REMARKS/ARGUMENTS

AMENDMENTS TO THE DRAWINGS

Fig. 3

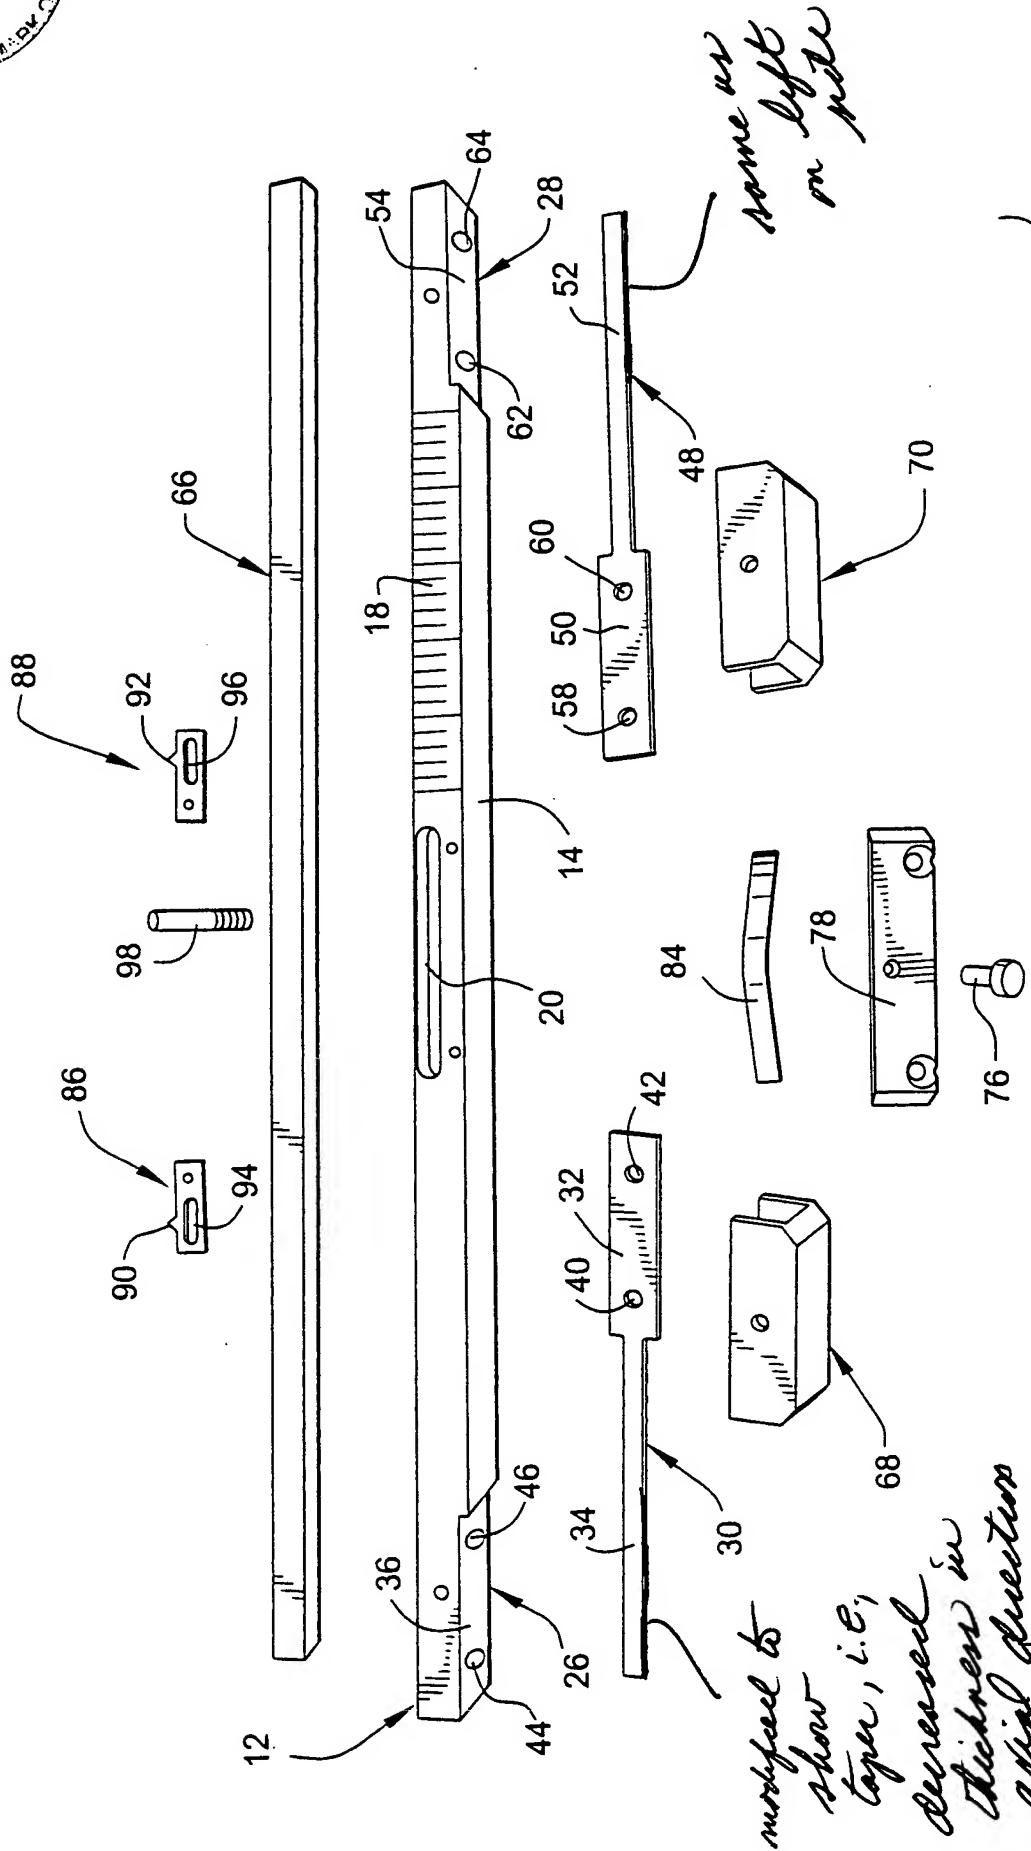
The Examiner has objected to the drawings for failure to indicate that the feeler gages are taped.

The Examiner's attention is to Figures 1 and 2 where it is apparent that the feeler gages 34 and 52 taper in thickness in the axial direction. The Examiner will appreciate that because of the drawing scale, it is difficult to clearly illustrate a significant taper. In any event, and in order to make Figure 3 consistent with Figures 1 and 2, applicant proposes to amend the feeler gages 34 and 52 in Figure 3 to also reflect a taper in the axial direction. That there is such a taper is readily apparent and fully supported in paragraph 22 on page 8 where it is stated that:

This description along with the clear understanding in the art of exactly what a "tapered feeler gage" is understood to include (and, of course, given the taper shown in Figures 1 and 2), establish that the amendment to Figure 3 does not involve the introduction of any new matter.

Applicant proposes to amend Figure 3 as marked on red on the attached of original Figure 3.
